SITE SPECIFIC FIRE NOTES (REVISED - FIELD REVISION #3):

Urgent Care Facility
Prepared For MedExpress
5610 Williamson Road
Tax No. 038.10-05-07.00 & 038.10-05-08.00
Hollins Magisterial District, Roanoke County, Virginia
SP 1200723

SHEET TITLE:
Waterline Extension
Fire Hydrant
Location Change

FR#3
1 OF 1
PROJECT NUMBER:
12-0012-02

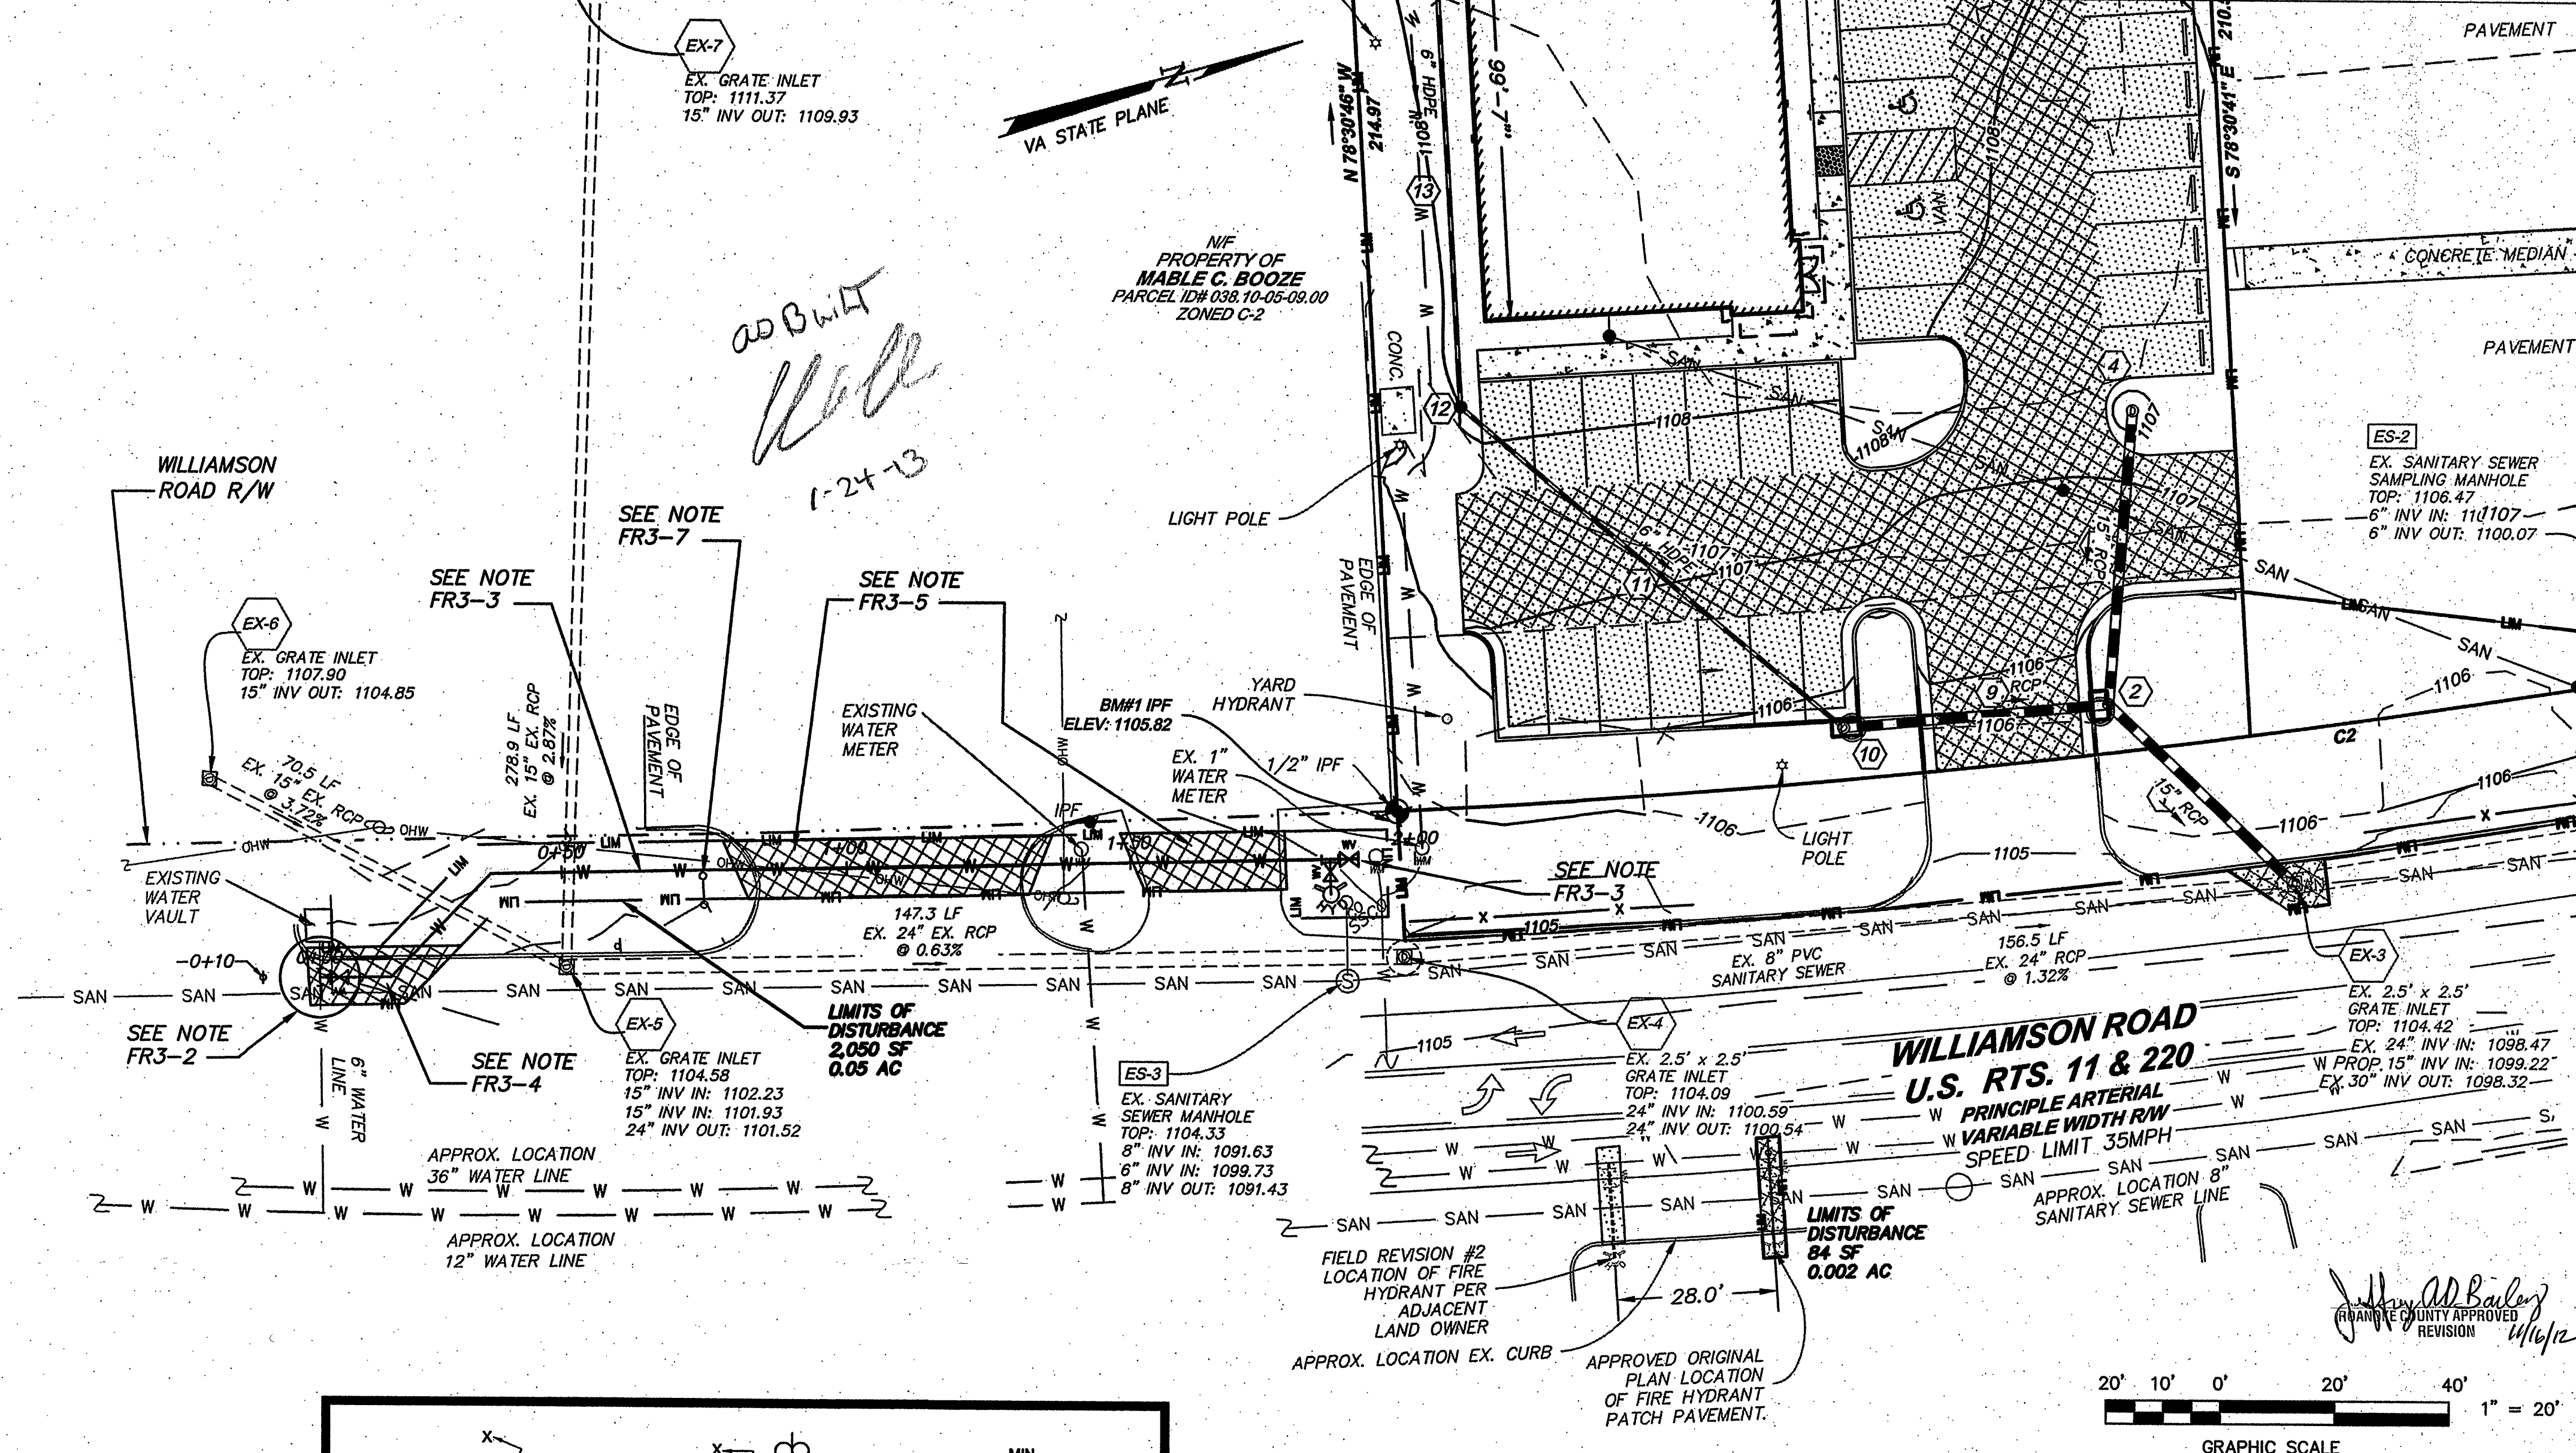
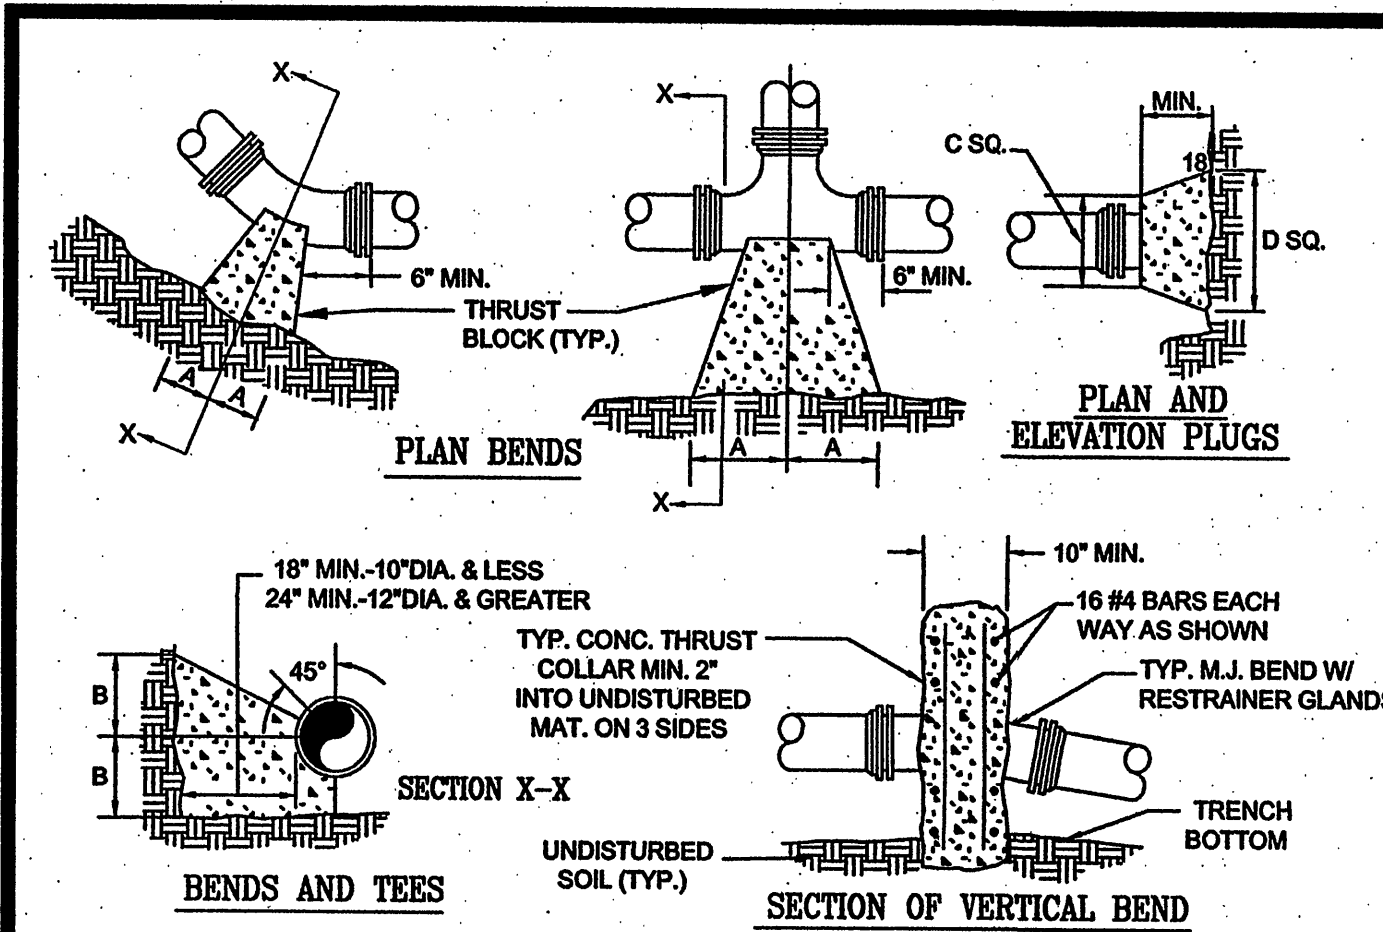
1. ORIGINAL HYDRANT LOCATION IS MODIFIED BASED ON EXISTING CONDITIONS IN WILLIAMSON ROAD. A DUCT BANK IS ADJACENT TO THE 12-INCH WATERLINE. AN 8-INCH WATERLINE EXTENSION IS PLANNED FROM AN EXISTING SMALL LENGTH OF 6-INCH LINE TO PROVIDE HYDRANT ON WEST SIDE OF WILLIAMSON ROAD AS WELL AS FUTURE CONNECTIONS.

2. THE WWA IS TO PROVIDE CONNECTION TO EXISTING 6-INCH LINE WITH 6X6X6 TEE, 6X8 EXPANSION, AND INSTALLATION OF GATE VALVE. THIS WORK IS ANTICIPATED TO BE PERFORMED OVER THE WEEKEND OF NOVEMBER 17TH OR 18TH.

3. CONTRACTOR RESPONSIBILITIES BEGIN AT END OF ITEMS INSTALLED BY WWA. CONTRACTOR SHALL EXTEND 8-INCH LINE WITH C900 PIPE AND ASSOCIATED APPURTANCES. (185 LF ±) 8-INCH LINE SHALL TERMINATE WITH A "TEE, 8-INCH GATE VALVE, AND PLUG" BEYOND THE FIRE HYDRANT. THE WWA WILL PROVIDE THE 8-INCH GATE VALVE FOR TERMINATION.

4. WORK WITHIN PAVED SHOULDER WILL REQUIRE TRAFFIC CONTROL DEVICES FOR TEMPORARY SHOULDER CLOSURE.

5. CONTRACTOR SHALL CROSS TWO (2) EXISTING ENTRANCES. SHOULD OPEN CUT OF ENTRANCE OCCUR, CONTRACTOR SHALL MAINTAIN ONE LANE OF TRAVEL AT ALL TIMES. CONTRACTOR SHALL BE AWARE OF VDOT REQUIREMENTS FOR PAVEMENT PLACEMENT, ESPECIALLY TEMPERATURE REQUIREMENTS. PAVEMENT REMOVAL/REPLACEMENT SHALL BE IN ACCORDANCE WITH VDOT LUP-SP, INCLUDING BUT NOT LIMITED TO: NEAT VERTICAL SAW-CUTS, MATCH EXISTING PAVEMENT SECTIONS, PROVIDE PAVEMENT REPLACEMENT PER DETAILS.

6. REFERENCE IS DIRECTED TO PLAN AND PROFILE FOR LOCATION OF ADJACENT UTILITIES. ALL UTILITIES SHALL BE PROTECTED. UTILITIES SUCH AS GAS, TELEPHONE, ELECTRIC, ETC ARE OF UNKNOWN, ESTIMATED DEPTHS.

7. THE WATERLINE EXTENSION WILL REQUIRE RELOCATION/REPLACEMENT OF SIGNS AS NOTED ON THE PLANS. LOCATION OF UTILITY POLES ARE ALSO SHOWN. SPECIAL CARE SHALL BE UTILIZED AS OVERHEAD LINES EXIST IN WORK AREA.
